**TONGASS BOULEVARD RECONSTRUCTION, PHASE II  
Contract No. BE23-125**

**ADDENDUM NO.: ONE**

**DATE ADDENDUM ISSUED: November 28, 2022**

**SURVEY CONTROL MAP**

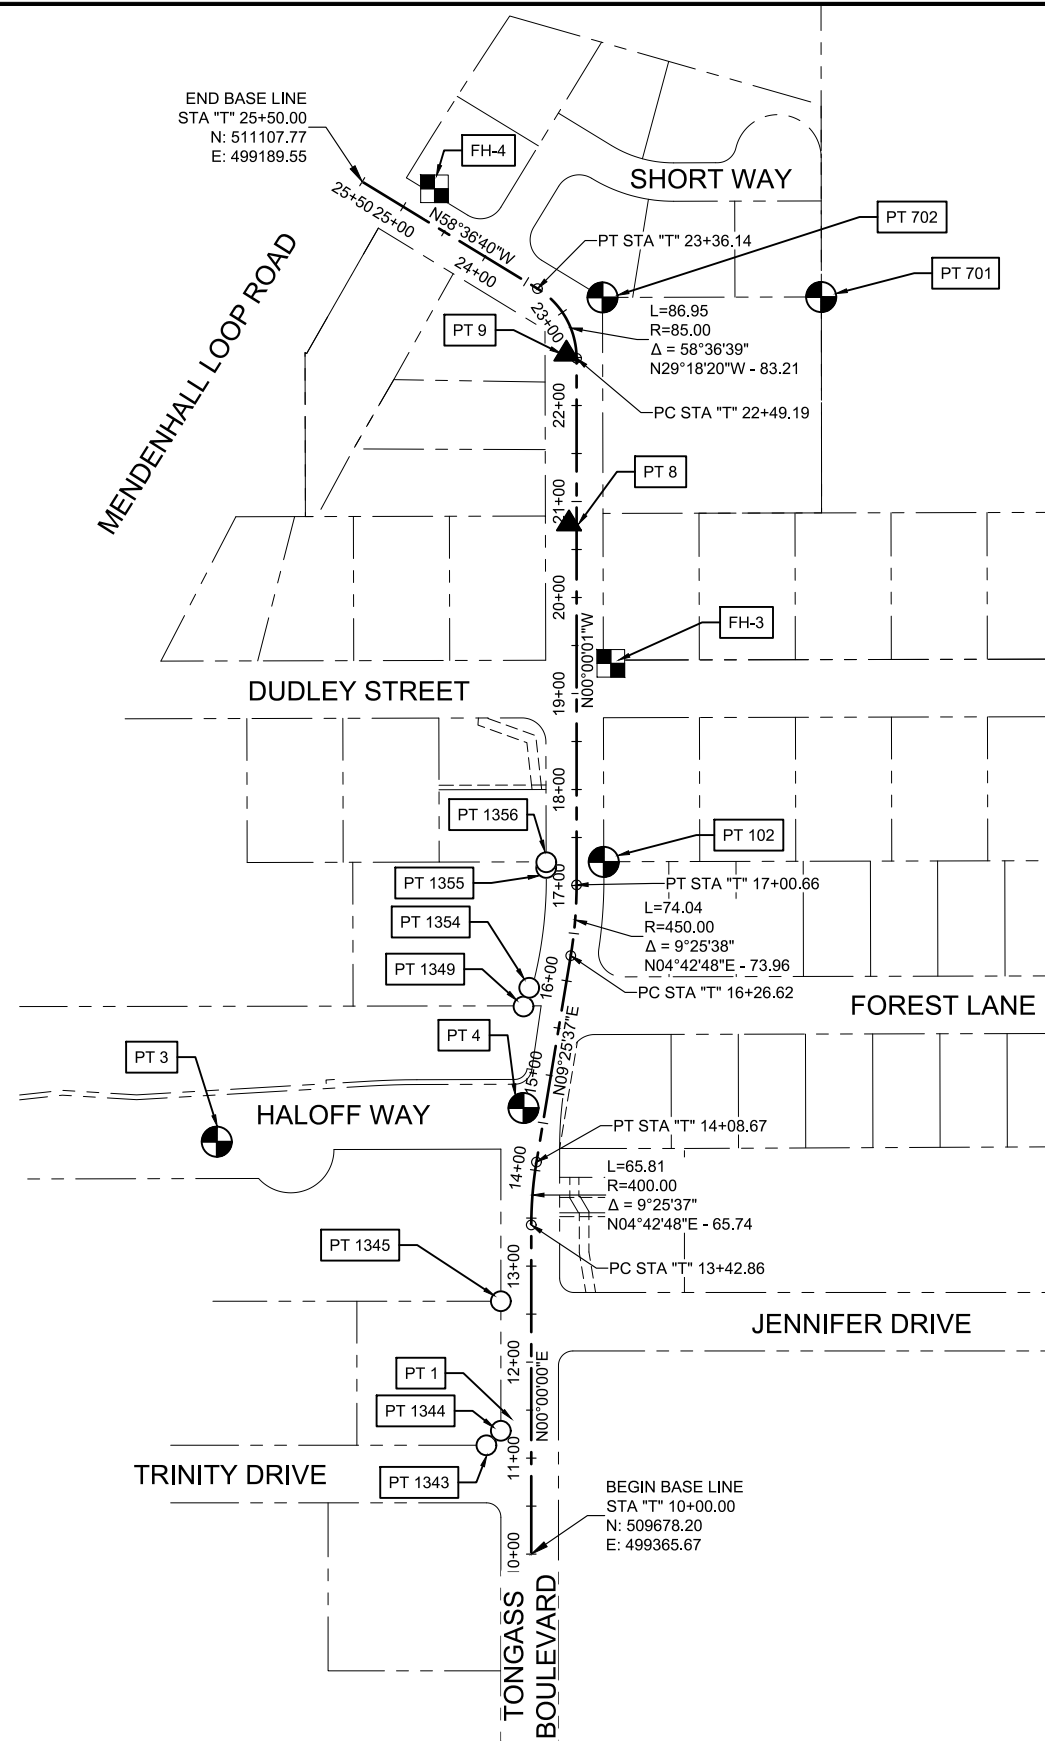
Item No. 5 SHEET C003, SURVEY CONTROL MAP  
**Replace** SHEET C003 **with** the attached SHEET C003
